## PRODUCT CHANGE NOTICE

**PCN#21-058**

**FL086-N Series (See below)**

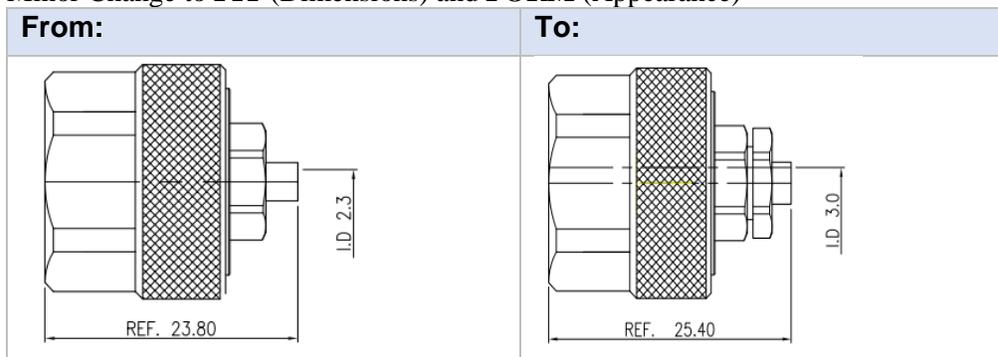
Change to dimensions of the N-Connector

- No change to **FUNCTION** (Performance),
- Minor Change to **FIT** (Dimensions) and **FORM** (Appearance)

More robust assembly of the cable

On exhaustion of existing stock. Parts of either version can be used interchangeably
